subject: Paramount Palm Beach Traffic Review

The Corradino Group, Inc (Corradino) has been requested to provide a traffic review of the Traffic Impact Evaluation for the redevelopment of the Paramount Theatre located at 139 North County Road in the Town of Palm Beach, Florida. The following are our traffic review comments based on the 04/18/23 resubmittal.

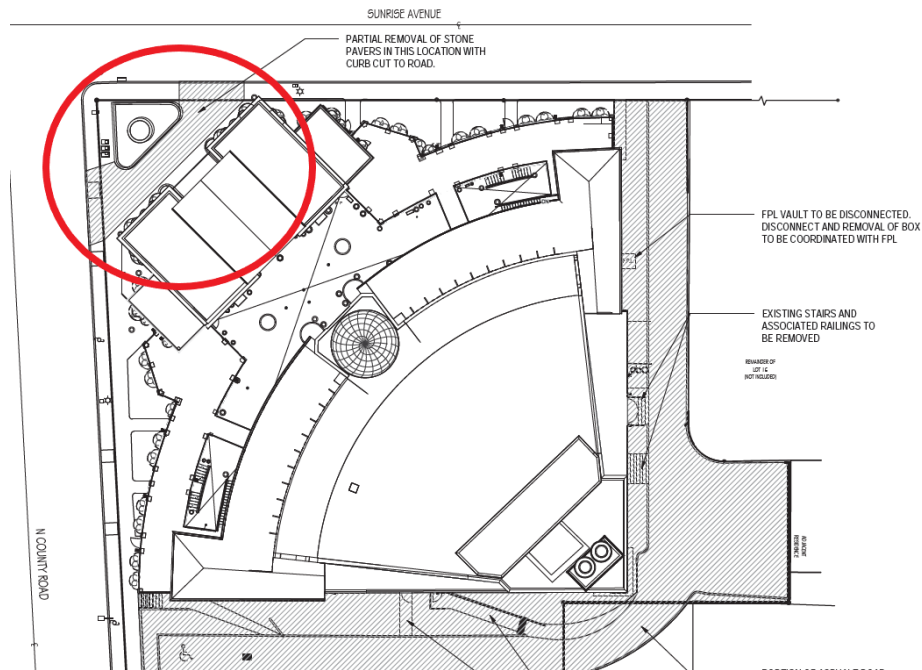
12. Please provide additional narrative that provides the total amount of queuing available from the valet stand to the adjacent road network for both scenarios. Figures 3 and 4 should be updated to denote the total amount of queuing available from the valet stand to the adjacent road network.

**Kimley Horn and Associates, Inc.'s 03/09/23 Response** Additional information is provided in the updated report and Figures 3 and 4 illustrating the queuing available to the adjacent road network. Note that the valet stand for the event space is proposed to be located on North County Road.
